APPLICATION NO.	FILING DATE	FIRST NAMED INVENTOR	ATTORNEY DOCKET NO.	CONFIRMATION NO.
10/748,943	12/29/2003	Neil Keegstra	1122-8	7887

Office Action Summary

DETAILED ACTION

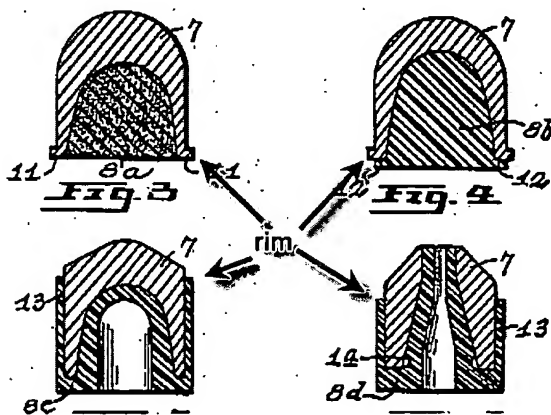
Lyon discloses an "extended range" non-lethal projectile comprising a protruding convex portion 5, and a cylindrical bore (the space circumscribed by the area of the projectile base 4). The body is formed from a non-metallic material (plastic and foam rubber) that inherently (same material as claimed by applicant) has a durometer hardness less than metallic rounds. The convex portion clearly adds forward weight to the round as it existed prior to the convex portion being added. Note that nothing in the claim limits the projectile to be made of a single material. The projectile has the same structure, i.e., the cylindrical bore, of applicants that produces an "extended range".
